♦ ♦ ♦ ♦ **ADDENDUM TO BID** ♦ ♦ ♦ ♦

PRE-ENGINEERED METAL BUILDING

Bid Title: PRE-ENGINEERED METAL BUILDING
Bid No.: 15-5300.PRE-ENGINEERED METAL BUILDING
Addendum No.: 1
Issued: November 21, 2014

ADDENDUM TO: Pre-Engineered Metal Building
Bid No. 15-5300.PRE-ENGINEERED METAL BUILDING (Lube Center)
2:00 p.m., December 2, 2014

A2.3

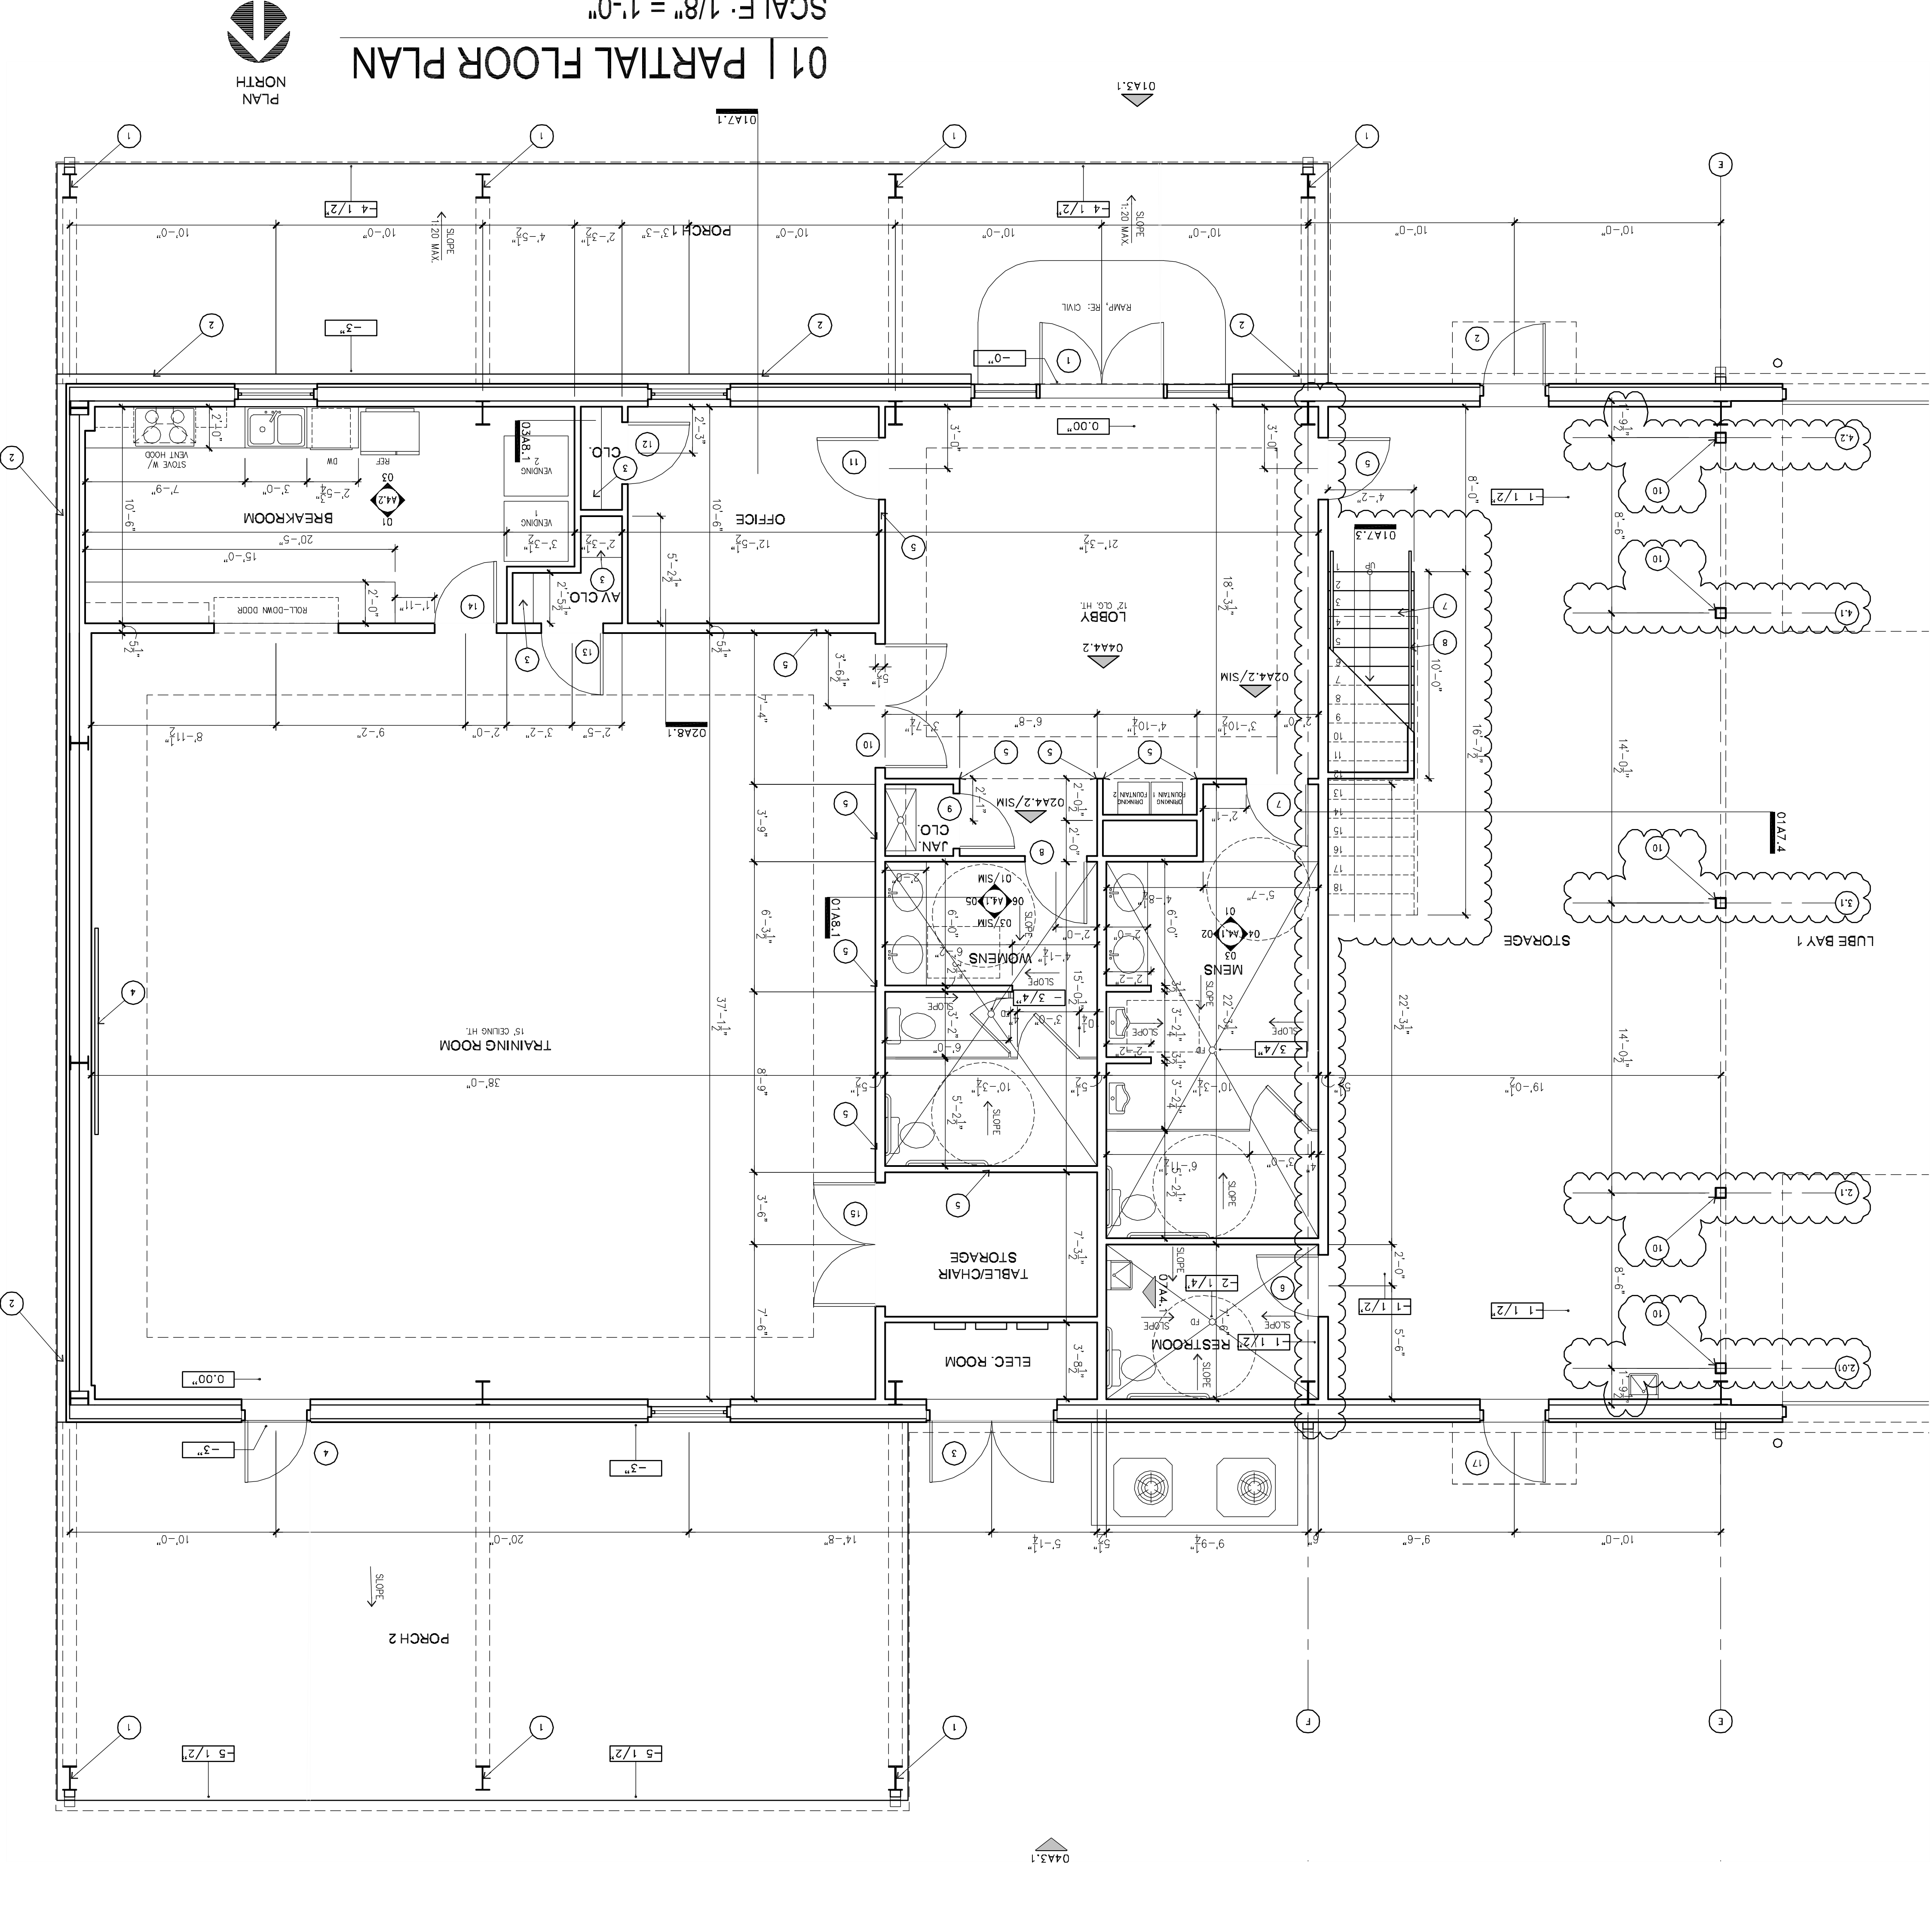
59. *Question:* Is the PEMB Manufacturer going to supply the 8x8 tube columns to support the 18" deep truss? No structural details are shown for these items either.

Response: No. See Sheets A2.3 and A7.4. See Sheet A2.3 (STR) for beam sizes.

A7.1

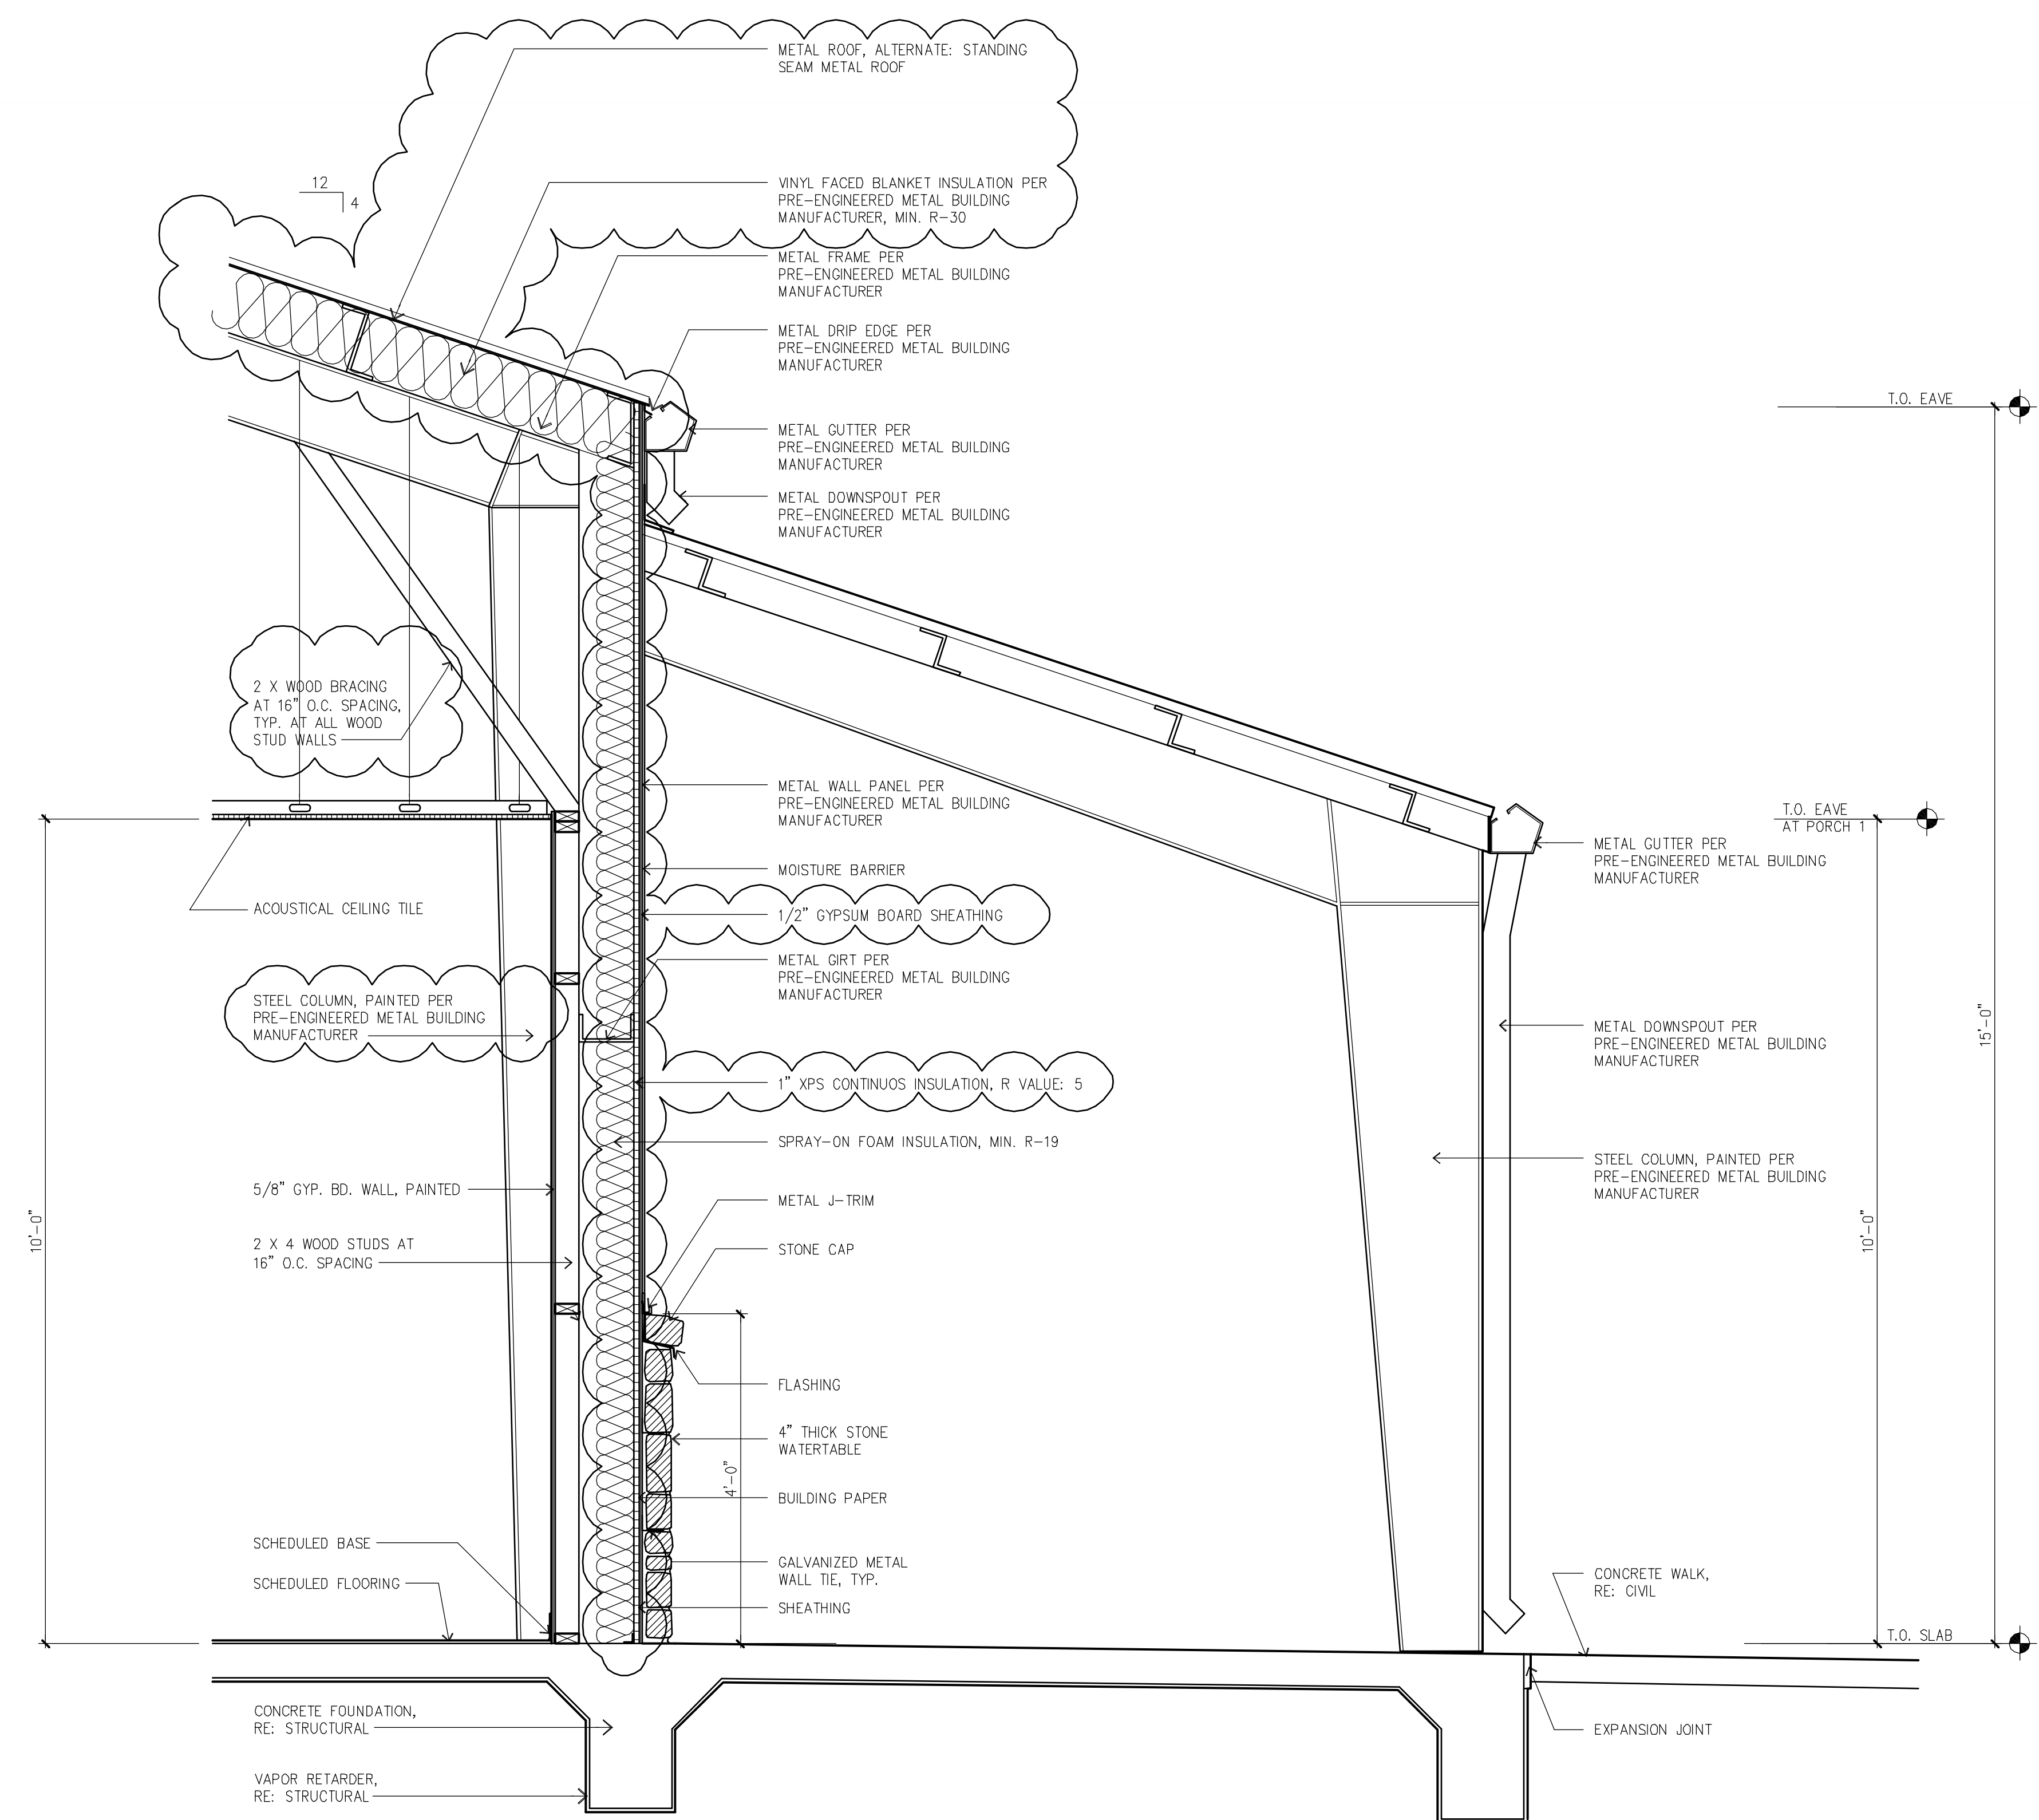
9. *Question:* What is the spacing for 2 x wood bracing as stud walls shown in detail 01/A7.1

10. *Question:* Are the metal building columns to be left exposed in Lobby, Break room, Restroom and Training Room?

49. *Question:* Is the 1" XPS insulation board at the roof to go over the purlins and the R-28 metal building insulation?

Response: See updated sheet A7.1

Response: See updated sheet A7.1

Response: See updated sheet A7.1.

01 | STAIR SECTION AT STORAGE/STORAGE MEZZANINE

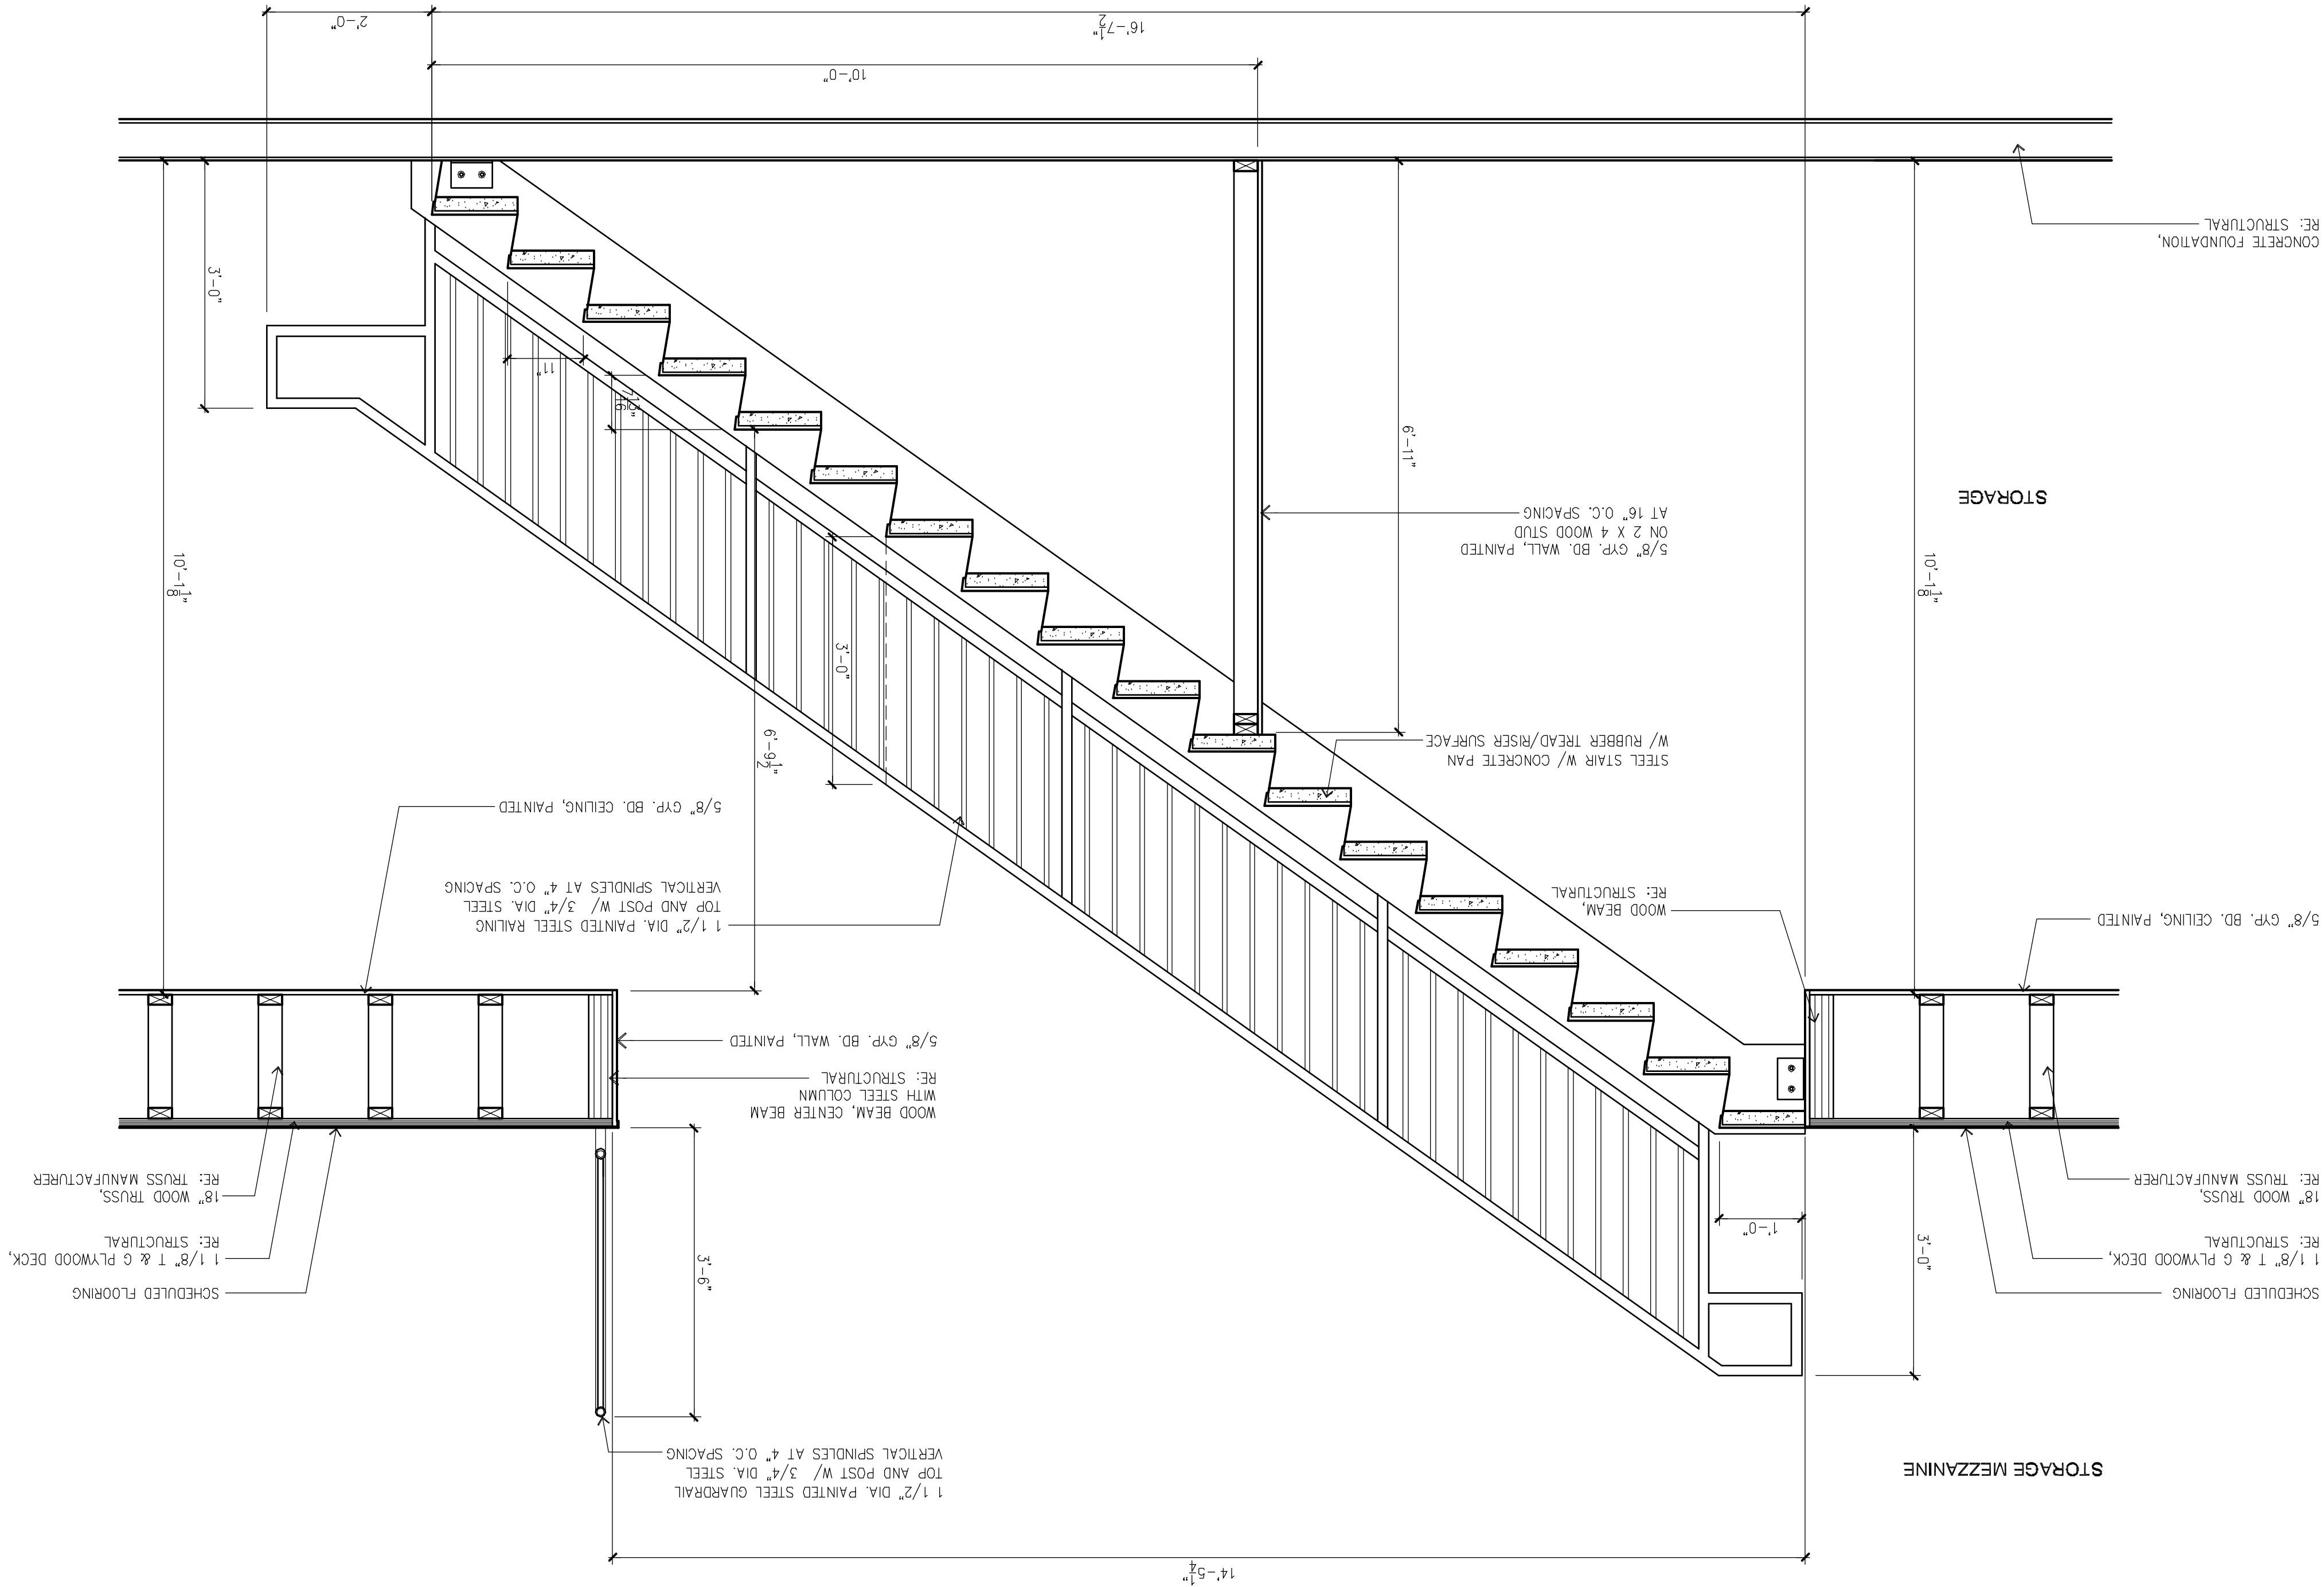
57. *Question:* Are the stairs to the mezzanine to be steel with concrete pan or checker plate treads? No details are shown, and the rails are called out on sheet A2.3 as 1 ½ pipe with pickets.

Response: See sheet A7.3
